ADDENDUM #1 TO THE
TECHNICAL DRAINAGE STUDY
FOR
CIRCLE K @ SAHARA - MARYLAND

DS-5610
W.O. # C360-2209
October 4, 2022

**Re: Addendum #1 to the
CIRCLE K @ SAHARA - MARYLAND
Technical Drainage Study**

RESPONSE TO COMMENTS

Sahara 10-year
Worksheet for Irregular Channel

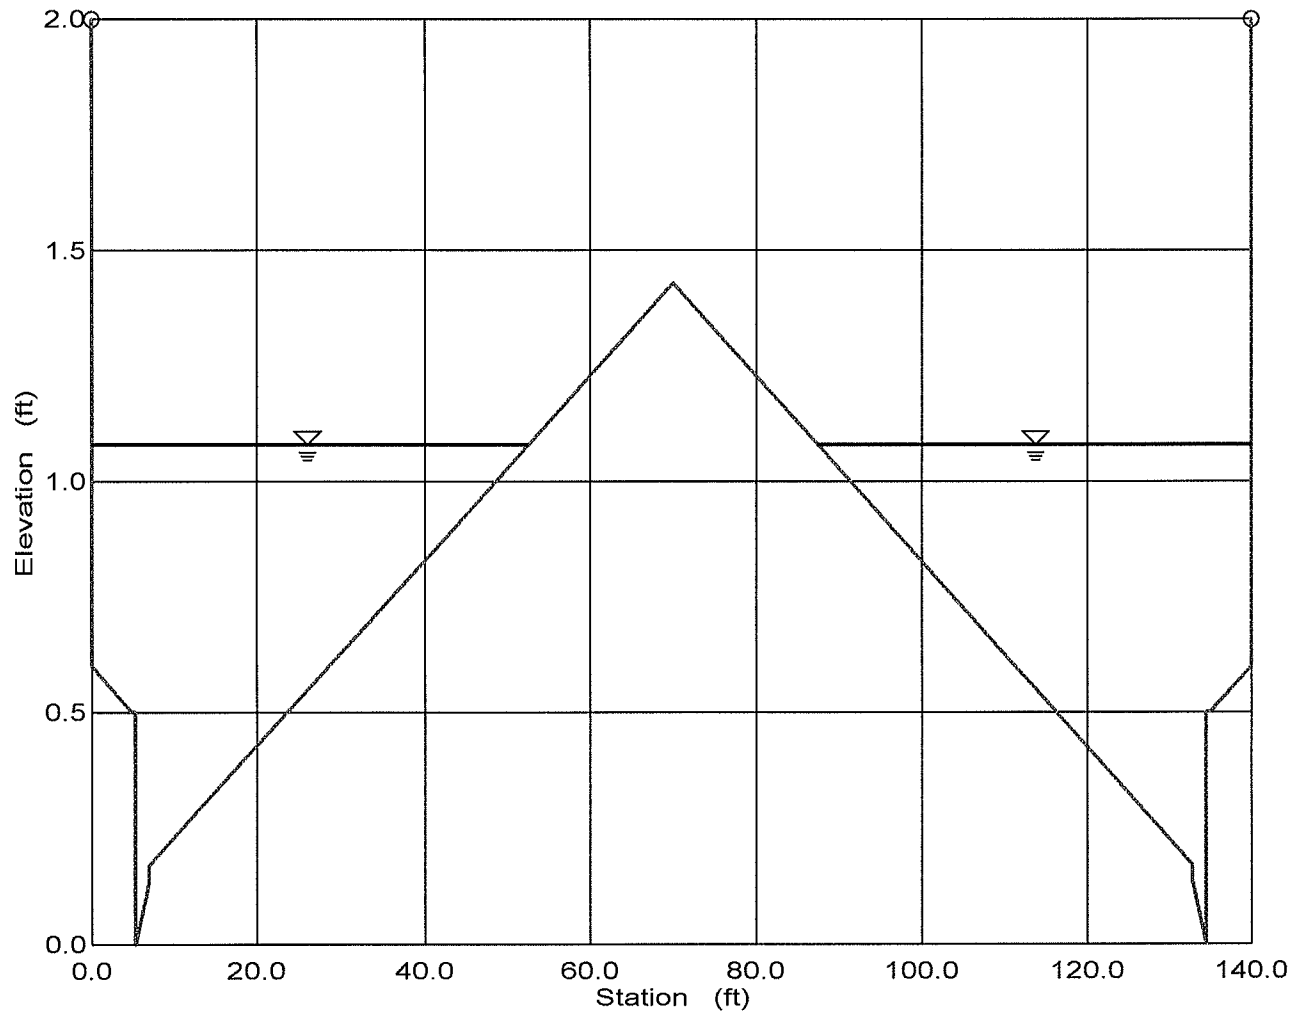
Comment 5. The proposed onsite berm must protect the site from twice the depth of flow within Sahara Avenue to protect the finished floor. Note this means the entirety of the southern boundary must contain the water in Sahara Avenue.

Comment 7. The following finish floors do not meet the Regional Flood Control District minimum criteria of twice the Q_{100} depth of flow up to 18-inches above the water surface (CCRFCD Manual Section 304.4. E.1) or 6-inch minimum above the highest adjacent top of curb (CCRFCD Manual Section 1602 304.4. E.1). The following finish floors should be revised or alternate flood protection provided.

Response 5. We have replaced the berm with a 2-foot floodwall at the back of sidewalk. Recall the depth of flow in Sahara is 1.34-feet. Twice the depth of flow would be 2.68 feet above the gutter flow line or 2.08-feet above the back of walk. We have added this wall to the plans.

Response 7. The finished floor elevation is protected to twice the depth of flow in Sahara Avenue and as shown in the original study to twice the depth of flow onsite. Protection from Sahara is in the form of the floodwall. Recall the depth of flow onsite was less than the top of curb and the finished floor is greater than 6-inches above adjacent top of curb elevations.

Sahara 100-year
Worksheet for Irregular Channel

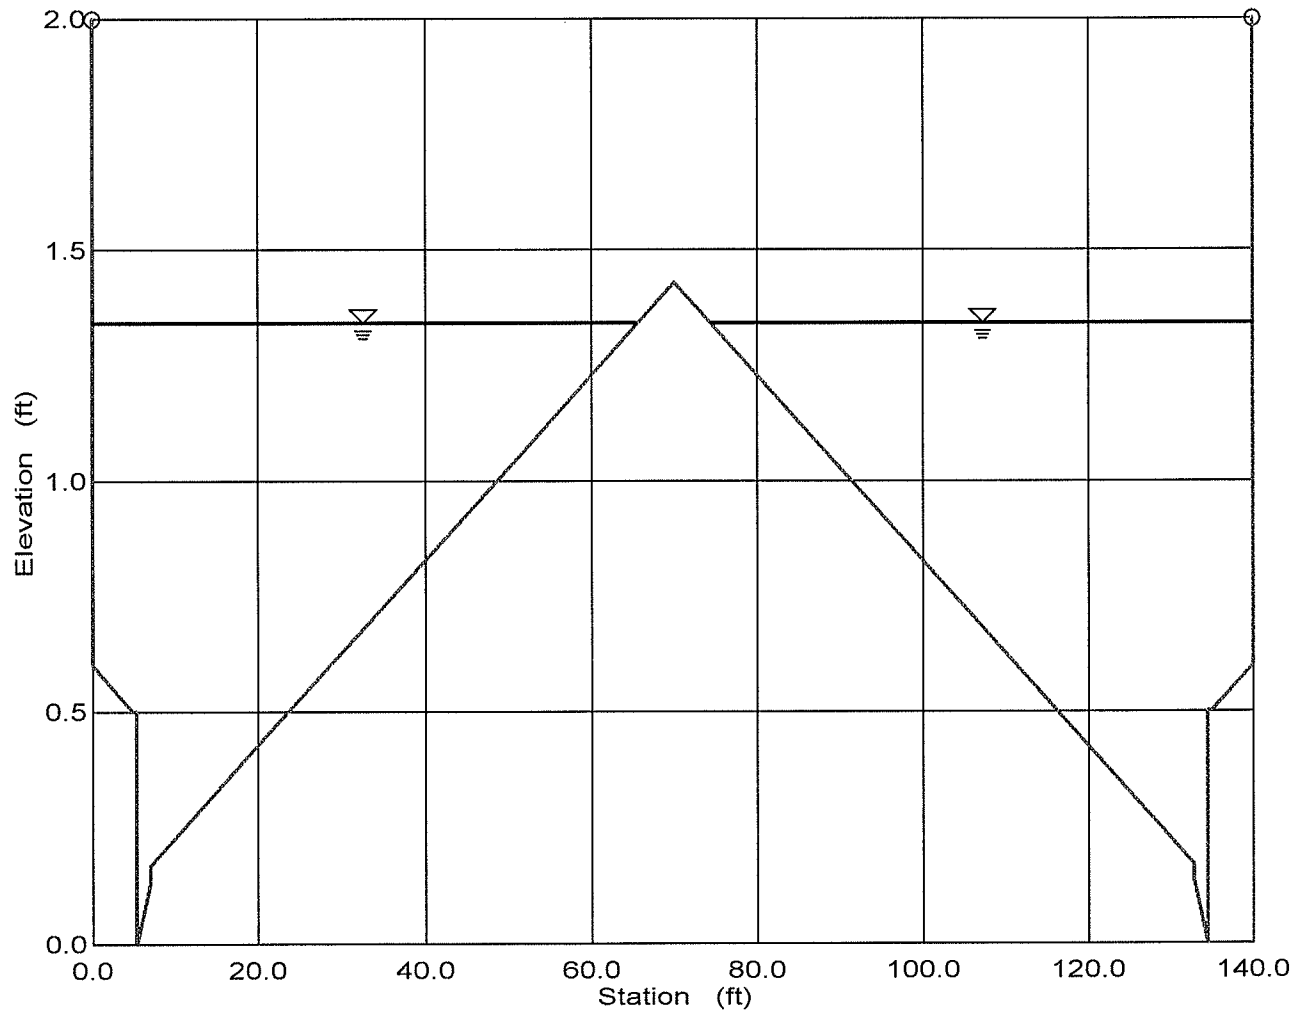
5. The proposed onsite berm must protect the site from twice the depth of flow within Sahara Avenue to protect the finished floor. Note this means the entirety of the southern boundary must contain the water in Sahara Avenue.

GRADING PLAN 2

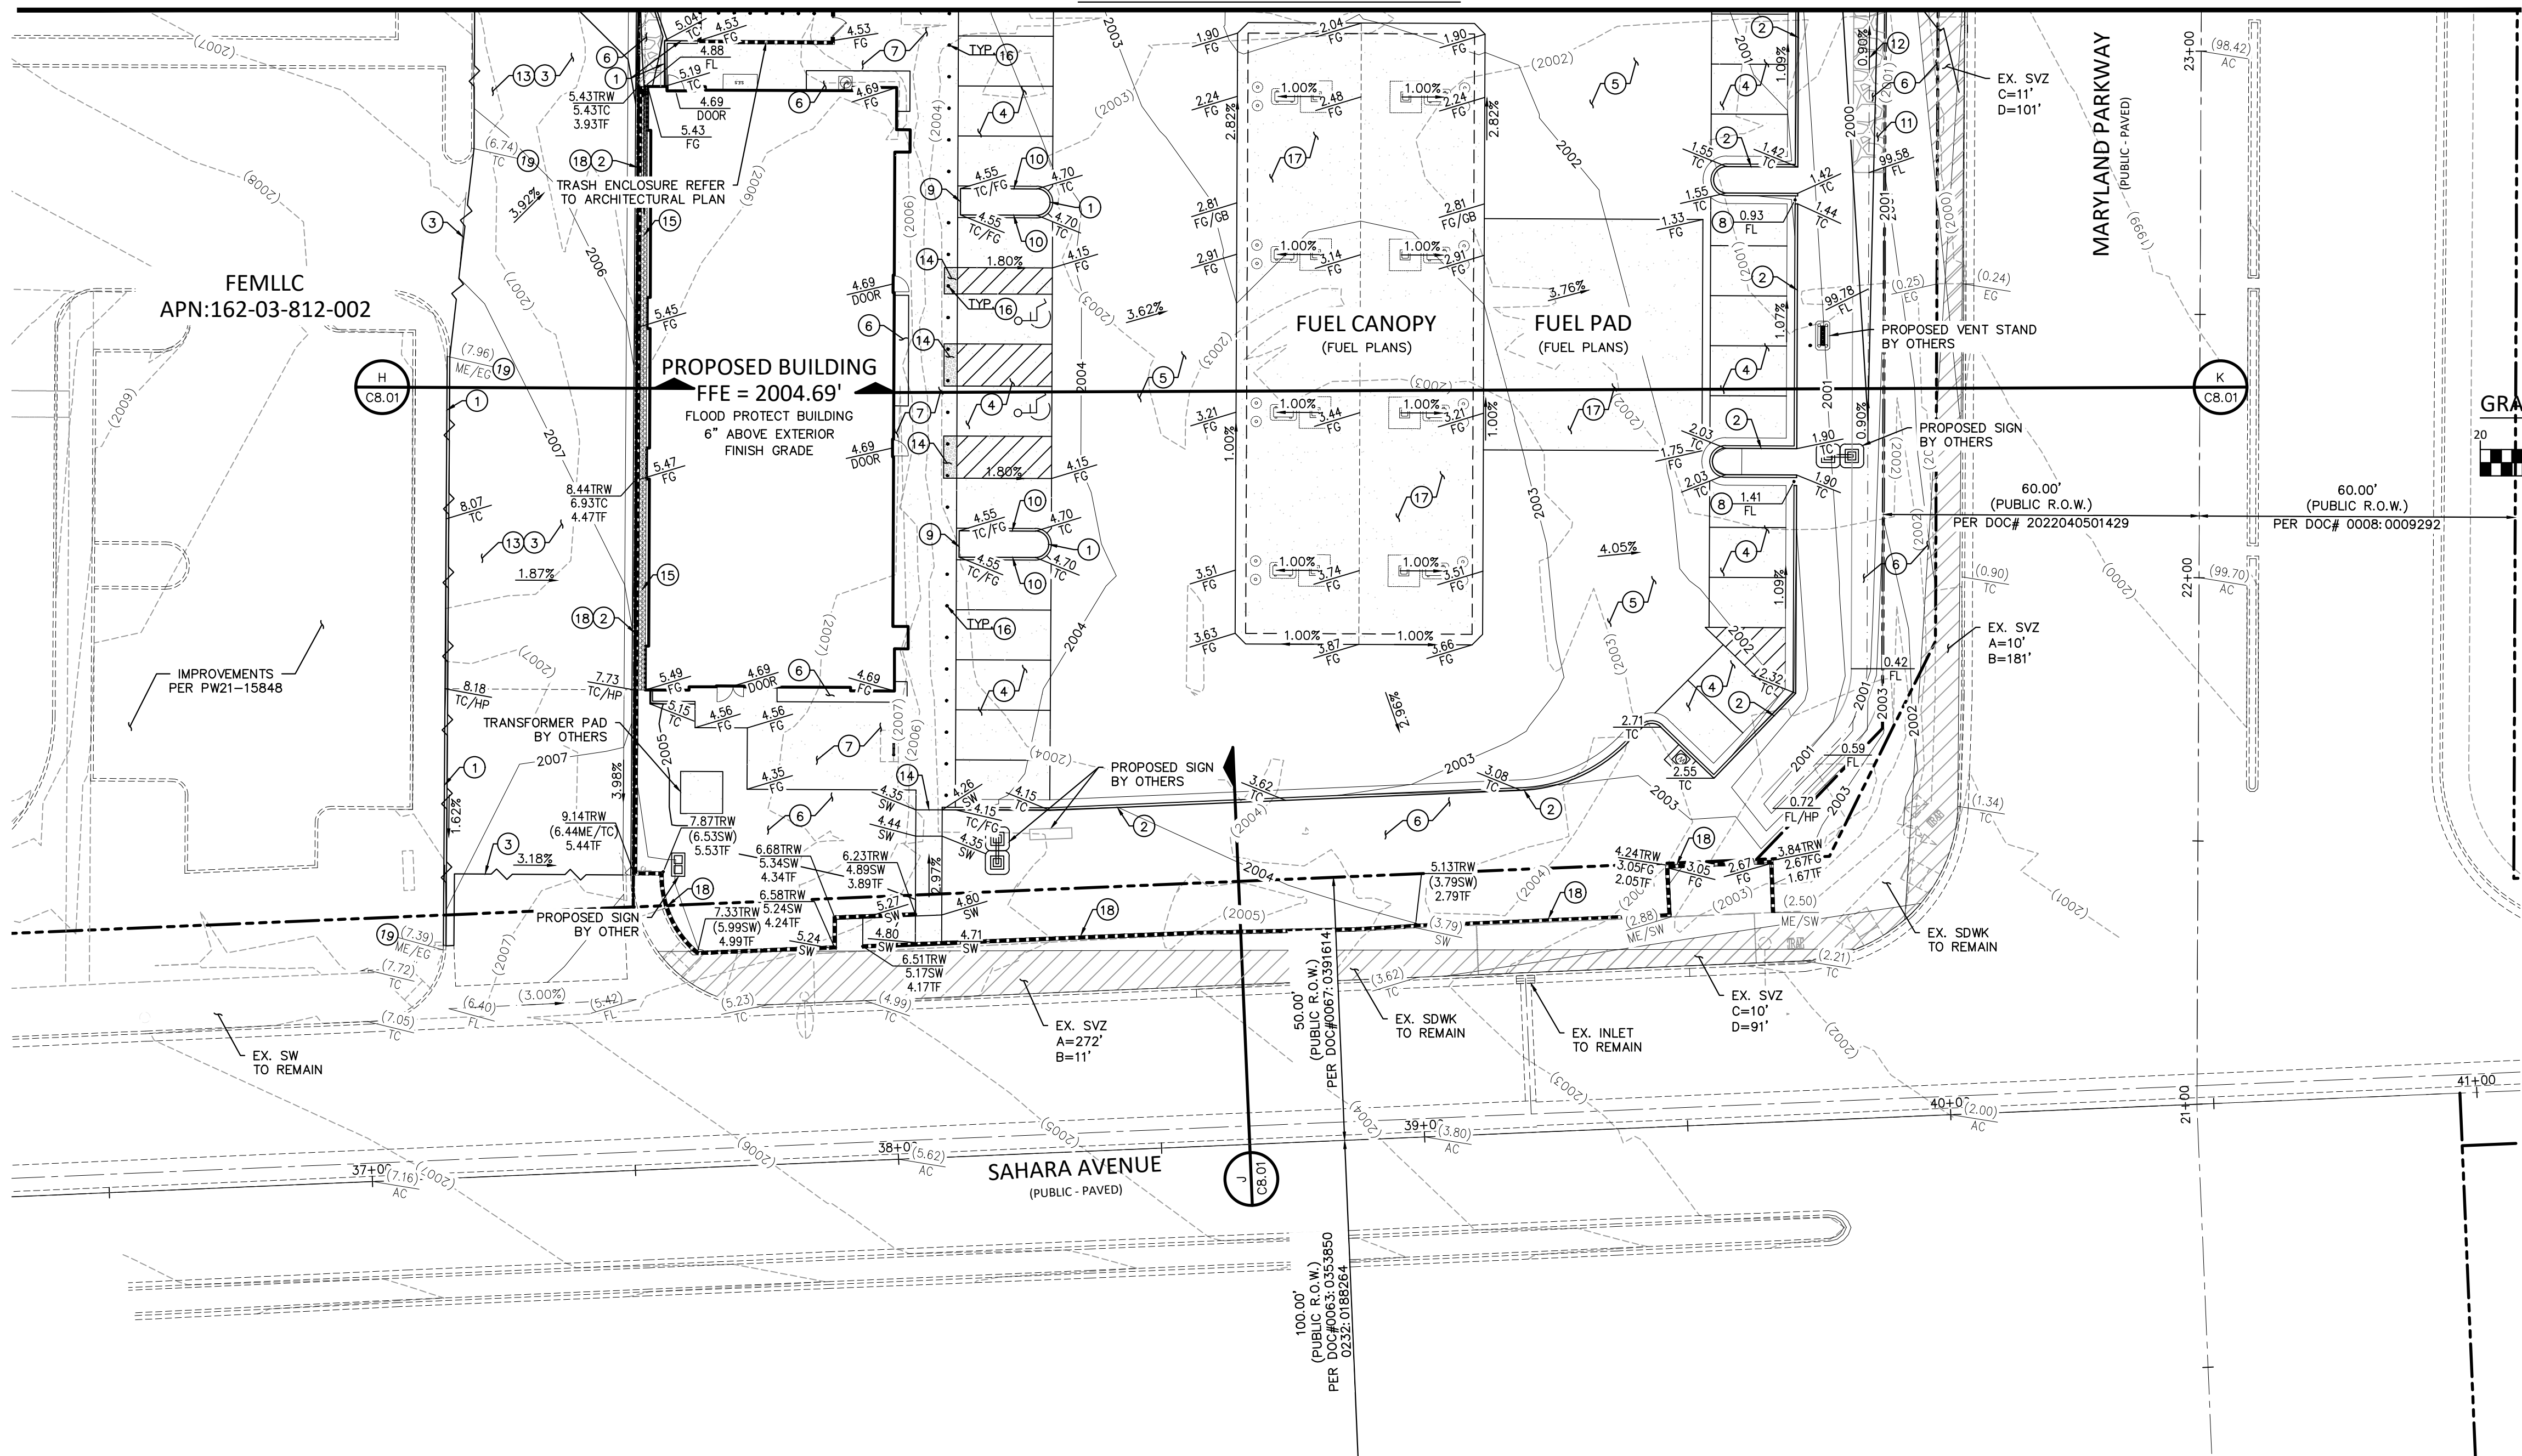
Comment 6. The flow in Sahara Avenue is above the back of sidewalk and erosive. Provide erosion protection for the landscape area in the form of a stem wall, riprap, or approved alternate as required in the Regional Flood Control District Manual in section 904.3. Revise the grading plan and sections accordingly.

Comment 10. Show the current off site grading on the grading plans and not the future condition. The future improvements shown do not match the current site.

Response 6. We have added a 2-foot floodwall at the back of sidewalk which should keep runoff in Sahara Avenue and eliminate the need for erosion protection.

Response 10. We have updated the plans to reflect the current condition of the offsite areas.
